Project #15-048
Logan Starbucks & Retail Building
Located at 730 South Main Street

Project Name: Logan Starbucks & Retail Building
Proponent / Owner: Terraform Companies / JKR Four 730 South Main LLC
Project Address: 730 South Main Street
Request: Design Review Permit
Current Zoning: Commercial (COM)
Type of Action: Quasi-Judicial
Hearing Date: October 8, 2015
Submitted By: Russ Holley, Senior Planner

Staff recommends that the Planning Commission **conditionally approve** a Design Review Permit for Project #15-048, Logan Starbucks and Retail Building, in the Commercial (COM) zone located at 730 South Main Street, TIN #02-063-0025.

A-201

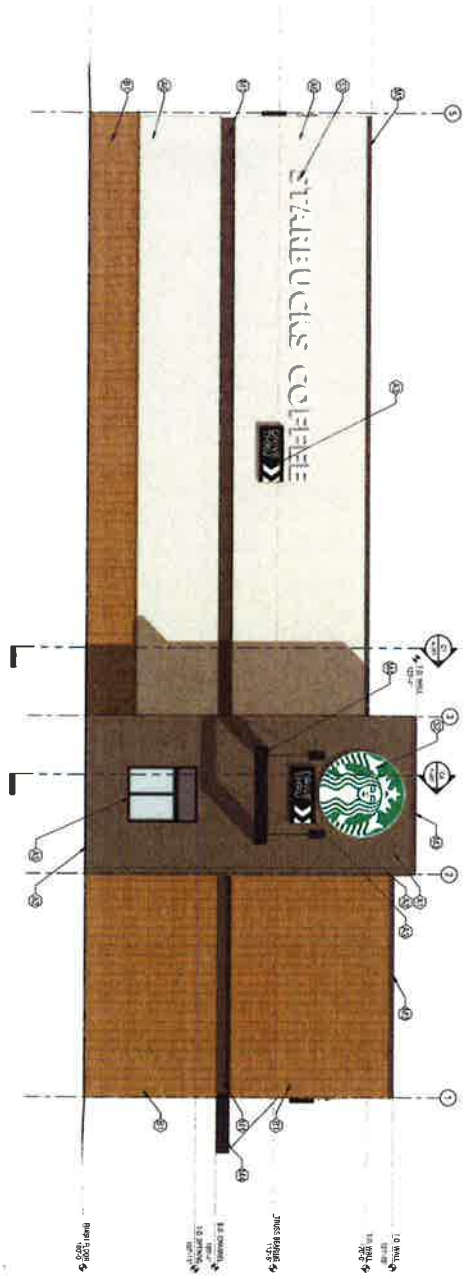
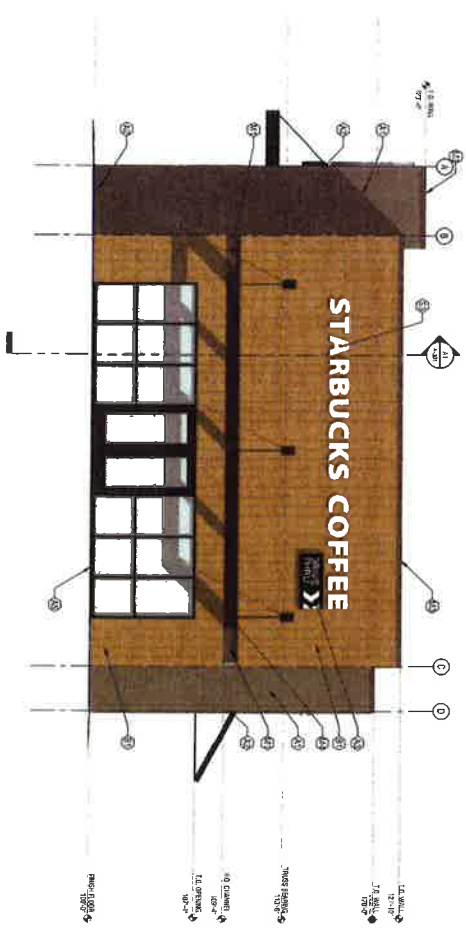
The LDC also requires a minimum of 30% transparency on ground floor street facing facades. With no windows proposed for the Starbucks street facing façade, and not considering the parapet wall (15' floor height), a total of 171 SF of window area would be required to meet LDC standards. The retail building as proposed has approximately 31% transparency, and complies with the LDC. As conditioned with 30% (171 SF) of transparency on the street facing façade for the Starbucks building, the project meets the minimum requirements in the LDC.

PRELIMINARY SITE PLAN

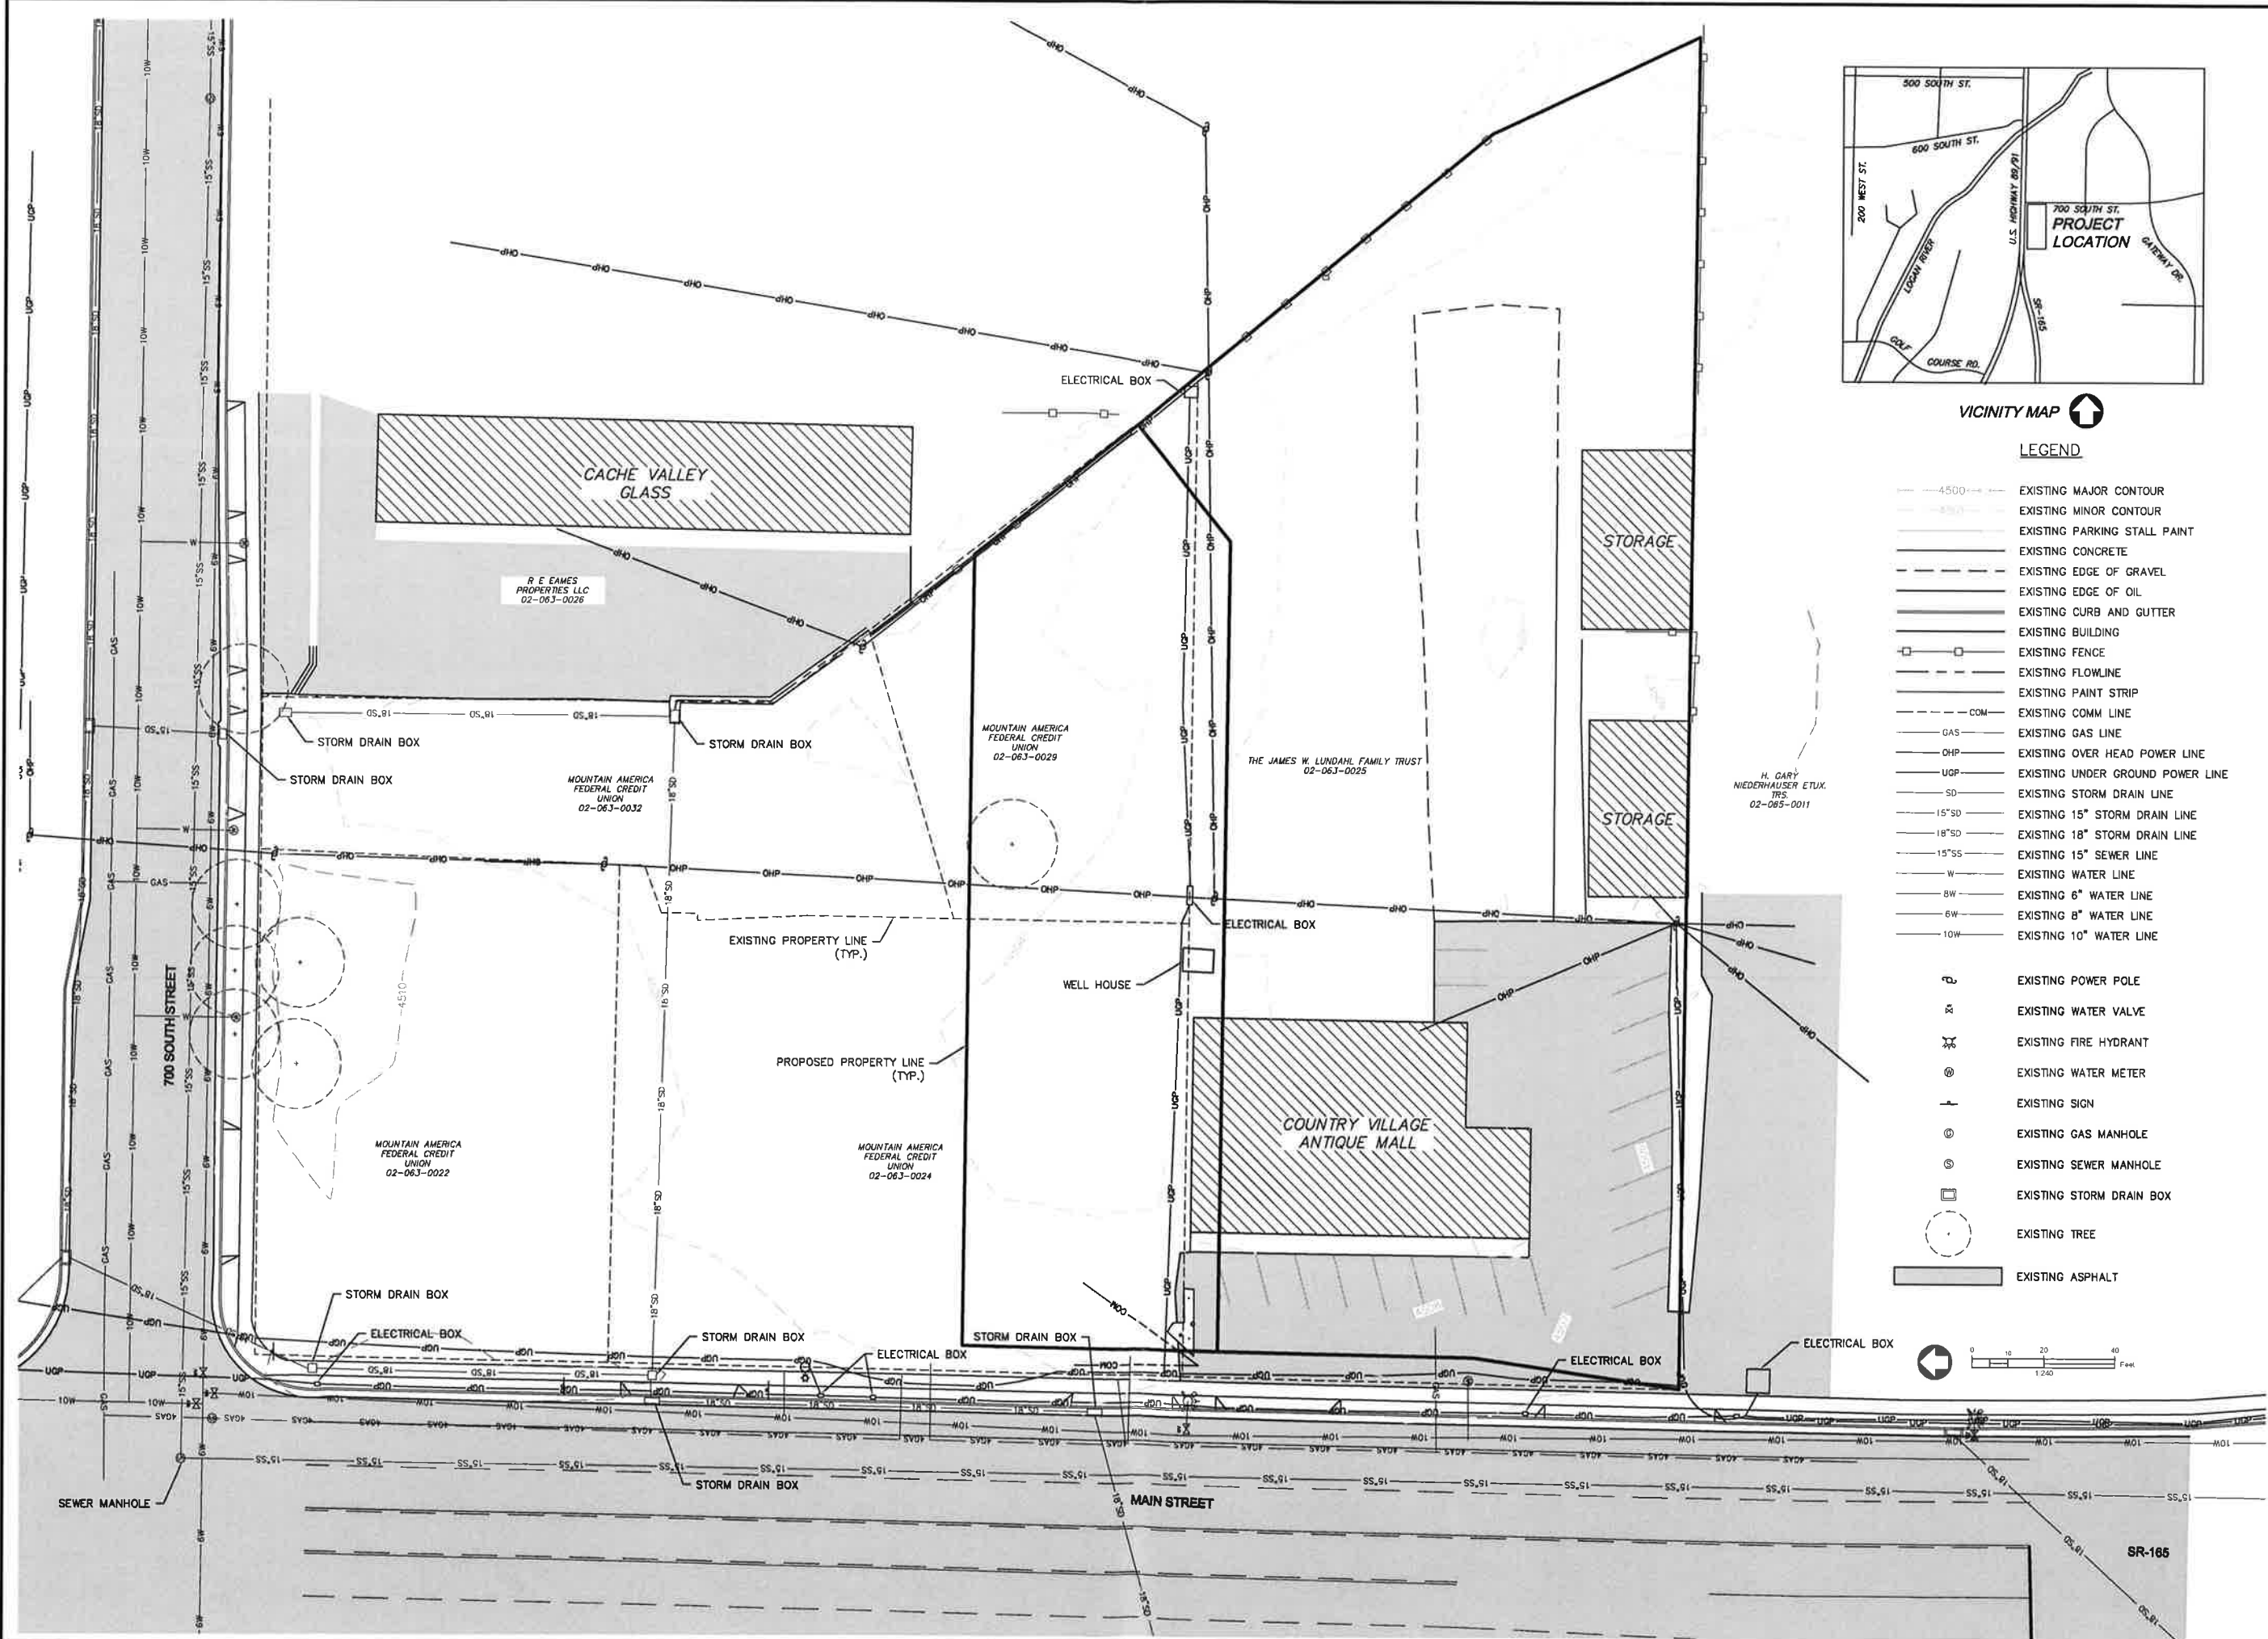
The LDC requires a pedestrian sidewalk connection between the building door and the adjacent street sidewalk and weather protection above public doors. The proposal includes a sidewalk connection from the street sidewalks to the multi-tenant building, but none connecting the Starbucks building. Weather protection is already shown on all but one public door. As conditioned with a sidewalk connection to the Starbucks building and weather protection above all public doors, the project complies with the LDC.

The LDC 17.38.070 requires one parking stall per every 150 SF for restaurants and one stall per every 250 SF of general retail. With a restaurant proposed at 2,200 SF (15 stalls) and a retail space proposed at 5,906 SF (24), the total number of parking stalls required would be 39 stalls. At 77 stalls proposed and 39 required, the project meets the LDC minimum parking stall requirements, but will exceed the requirement by more than 125% which triggers additional interior parking lot landscaping (18 SF to 36 SF) as per LDC 17.39.070. As conditioned with the additional landscaping, the project complies with the LDC.

The LDC 17.19.070 requires 10% open space and an additional 10% useable outdoor space of the project site. The LDC 17.35 generally describes open space as native vegetation or landscaped areas, while useable outdoor space is typically decks, patios and other similar amenities. The 1.42 acre (61,855 SF) site would require 6,185 SF of both landscaping and usable outdoor space for a total of 12,371 SF of open space. As proposed with open space areas totaling approximately 15,030 SF (24%) and landscape areas totaling 10,630 SF (17%), the project meets the open space area requirements of the LDC as proposed.

- Fire Apparatus Access from Main street on the West and the drive between the buildings appear to provide apparatus access within 150 ft of all portions of the facility as measured by an approved route around the exterior of the building.

- Fire hydrant FH00640 is located on the East side of Main Street at 730 South Main and within 400 ft of all areas of the buildings.
 - Fire Water Flow
